CHANGES TO SPECIFICATIONS

END ADDENDUM NO. 1

| PROJECT: NO. 102 THOMAS G. HAYES WINDOW REPLACEMENT | SCALE: | 3" = 1'-0" | SKETCH NO. | <small>GWGO INC. 800 WYMAN PARK DRIVE, SUITE 200 BALTIMORE, MARYLAND 21211, 410-332-1009 © 2010 GWGO INC.</small> |

| DRAWING: REVISED WINDOW DETAIL S1 (1/A8.3) | REV # | DATE | ADDENDUM NO. |  |

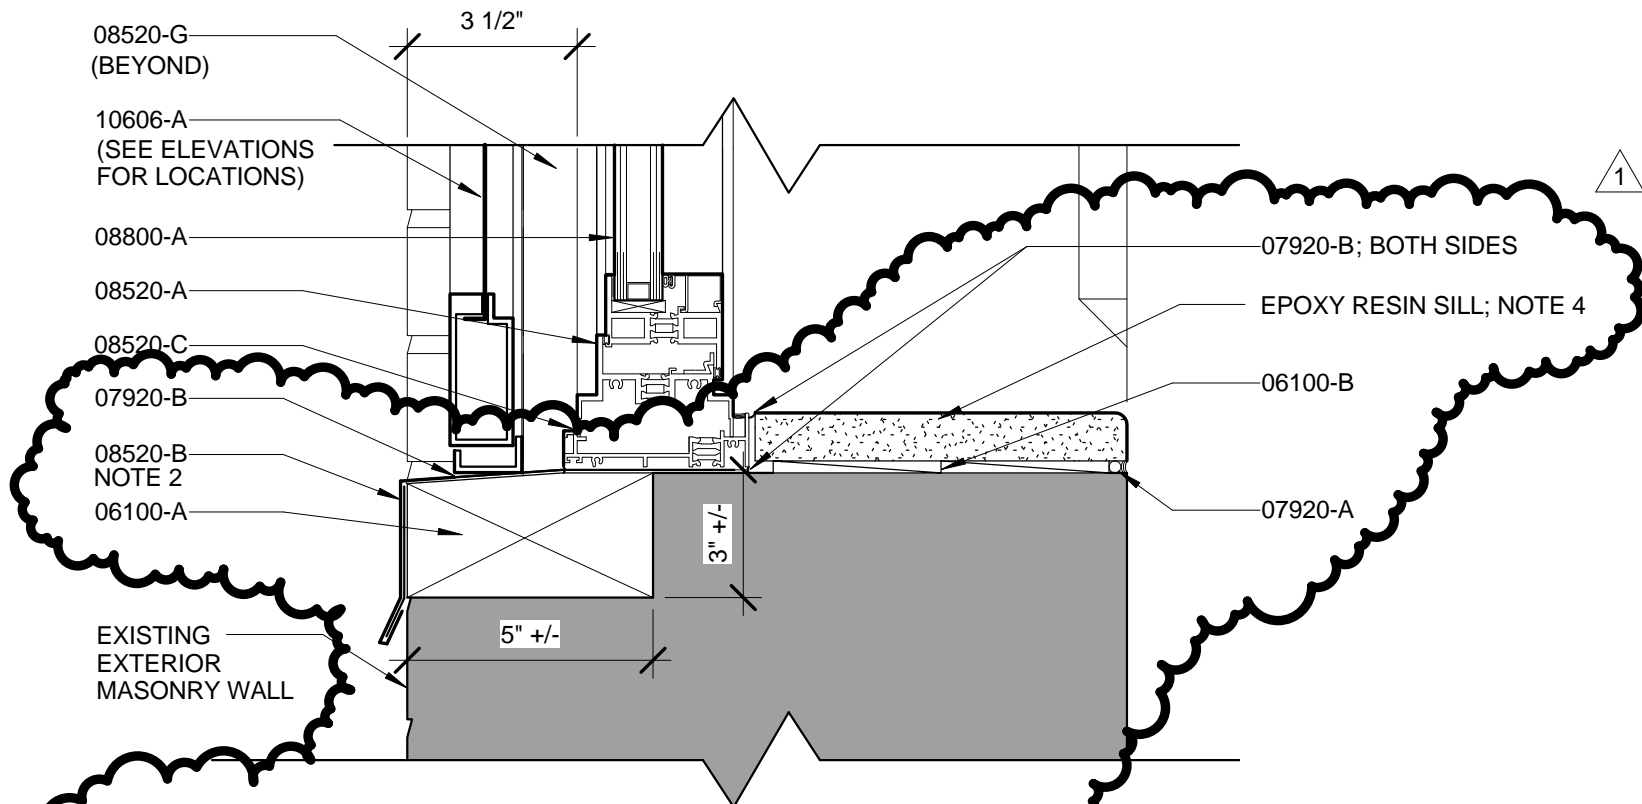
ADD1.10 DELETE Window Detail S1 on drawing 1/A8.3.
ADD SKA-01 (Revised Window Detail S1), attached.

- NOTE 1:** REMOVE EXISTING EXTERIOR STONE SILL AND ANY EXCESS MORTAR TO PREPARE FOR INSTALLATION OF NEW WORK.
NOTE 2: WRAP 06100-A; EXTEND UNDER 08520-C AS REQUIRED.
NOTE 3: 06100-A TO BE PRESSURE TREATED; CONTINUOUS.
NOTE 4: REFER TO SPECIFICATION SECTION 12362 FOR REQUIREMENTS.

| DRAWING: REVISED WINDOW DETAIL S4 (1/A8.3) | REV # | DATE | ADDENDUM NO. |  |

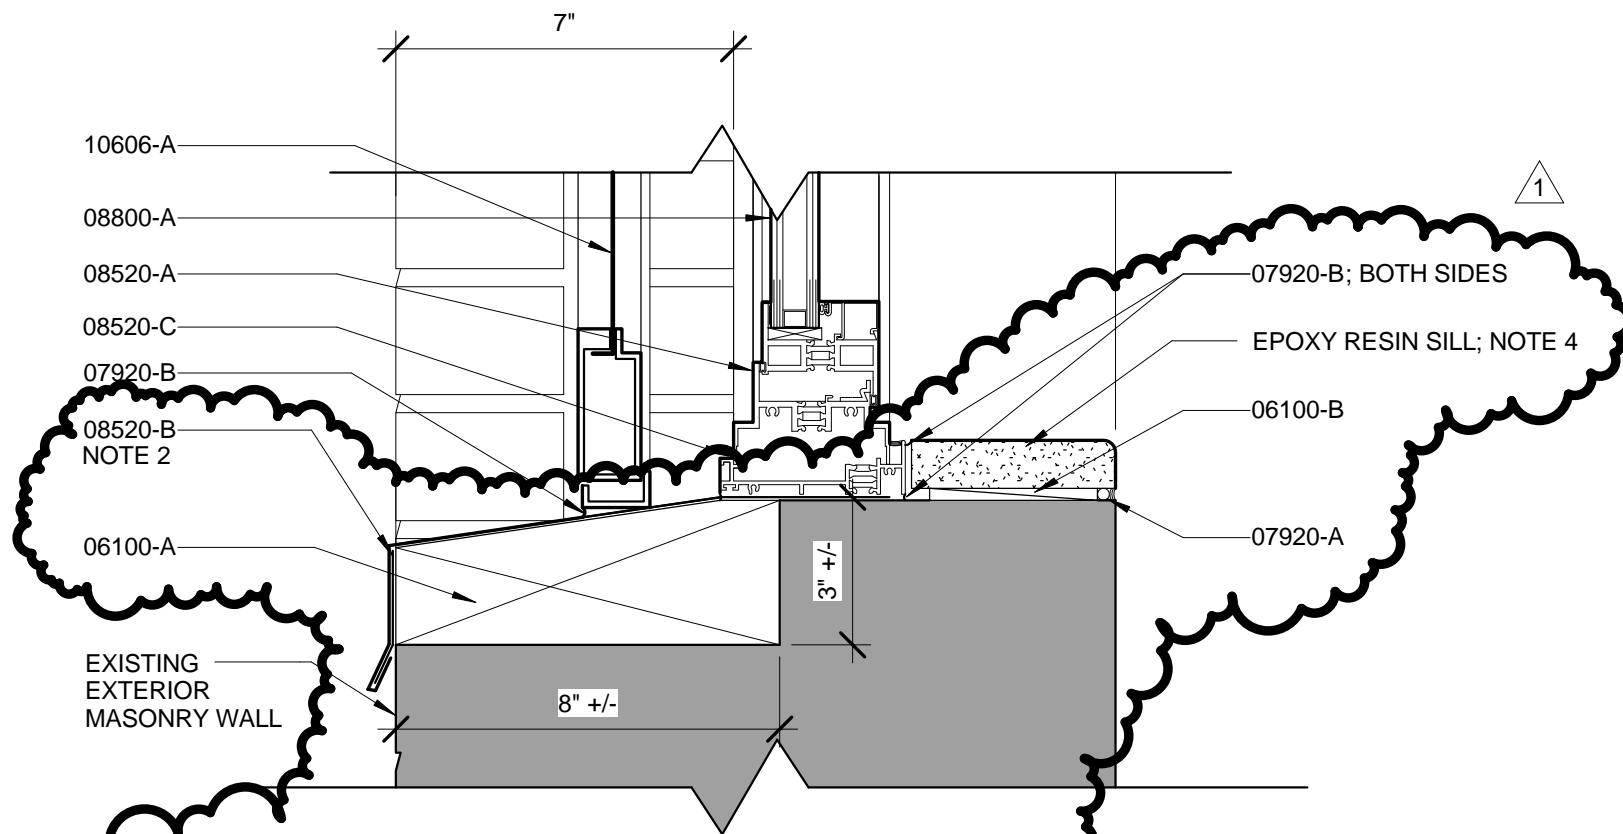
ADD1.11 DELETE Window Detail S4 on drawing 1/A8.3.
ADD SKA-02 (Revised Window Detail S4), attached.

NOTE 1: REMOVE EXISTING EXTERIOR STONE SILL AND ANY EXCESS MORTAR TO PREPARE FOR INSTALLATION OF NEW WORK.
NOTE 2: WRAP 06100-A; EXTEND UNDER 08520-C AS REQUIRED.
NOTE 3: 06100-A TO BE PRESSURE TREATED; CONTINUOUS
NOTE 4: REFER TO SPECIFICATION SECTION 12362 FOR REQUIREMENTS.

| DRAWING: REVISED WINDOW DETAIL S5 (1/A8.3) | REV # | DATE | ADDENDUM NO. |  |

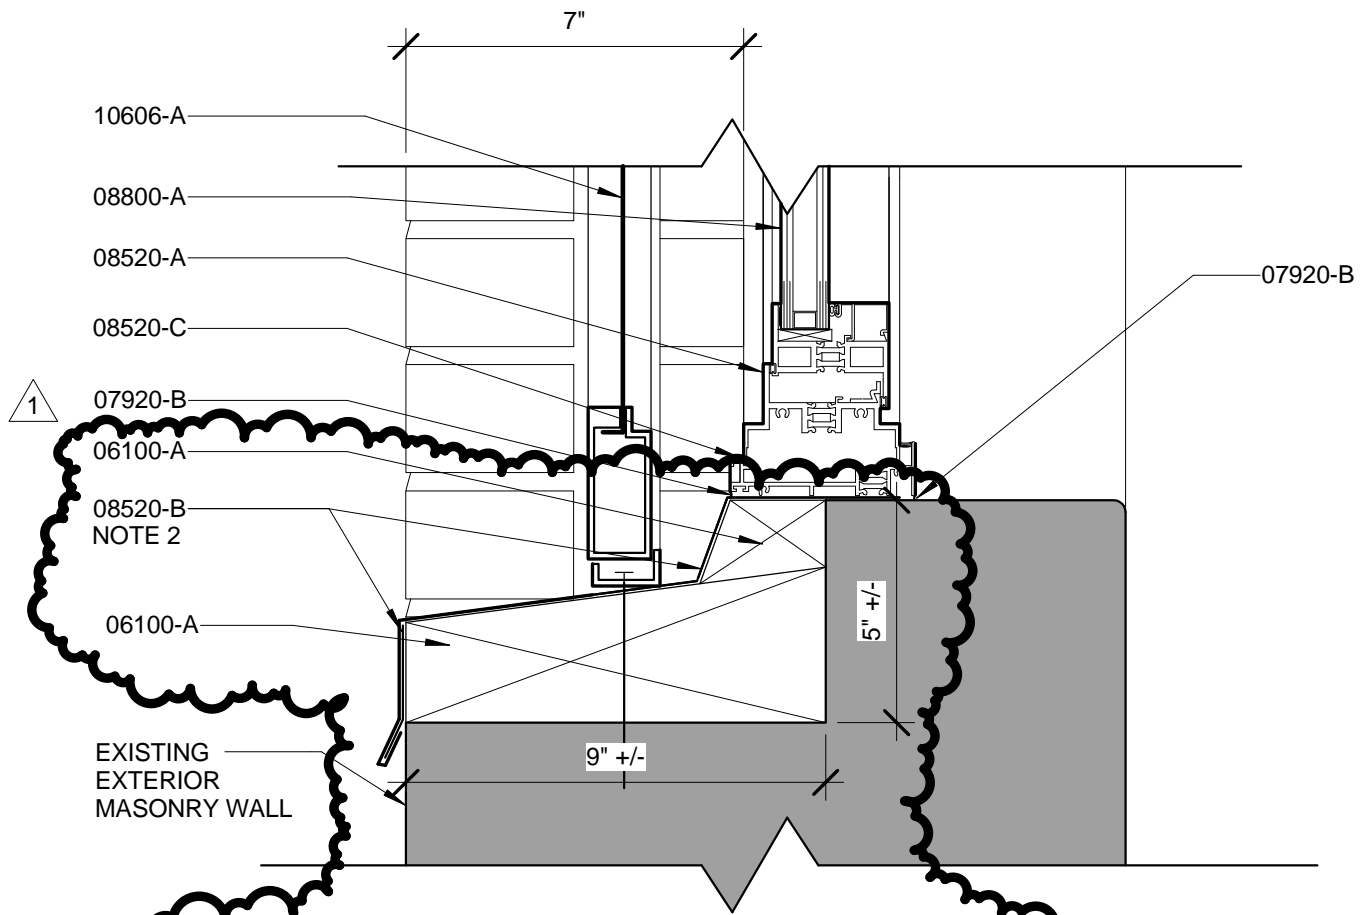
ADD1.12 DELETE Window Detail S5 on drawing 1/A8.3.
ADD SKA-03 (Revised Window Detail S5), attached.

NOTE 1: REMOVE EXISTING EXTERIOR STONE SILL AND ANY EXCESS MORTAR TO PREPARE FOR INSTALLATION OF NEW WORK.
NOTE 2: WRAP 06100-A; EXTEND UNDER 08520-C AS REQUIRED.
NOTE 3: 06100-A TO BE PRESSURE TREATED; CONTINUOUS

REVISED WINDOW DETAIL S6 (1/A8.3)

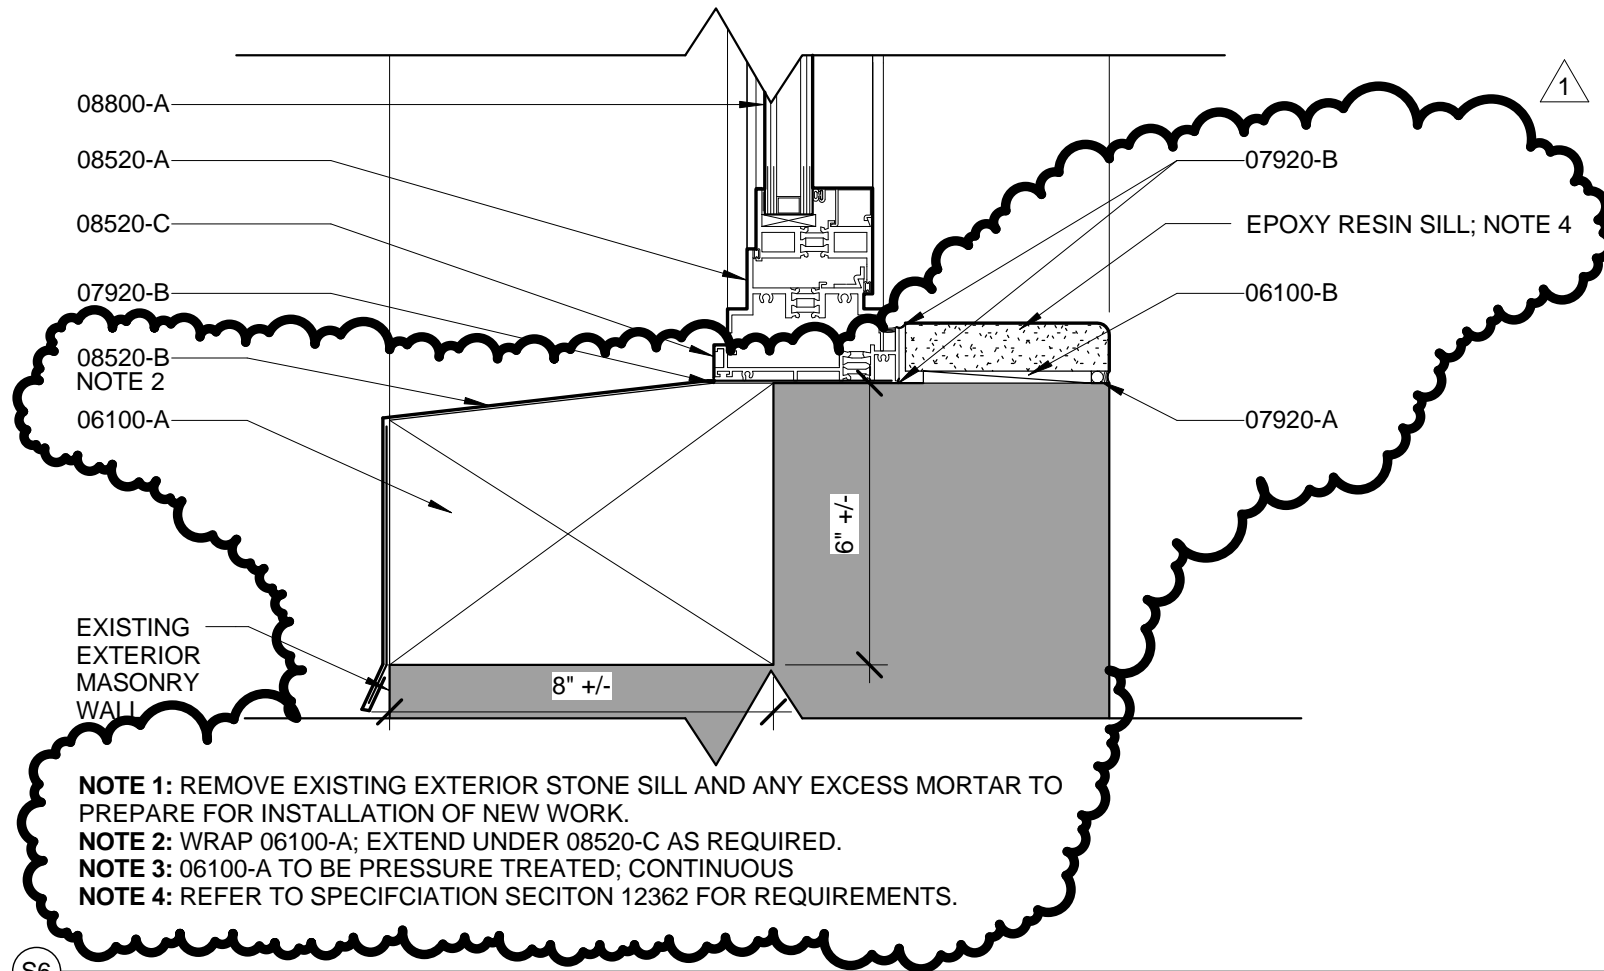
ADD1.13 DELETE Window Detail S6 on drawing 1/A8.3.
ADD SKA-04 (Revised Window Detail S6), attached.
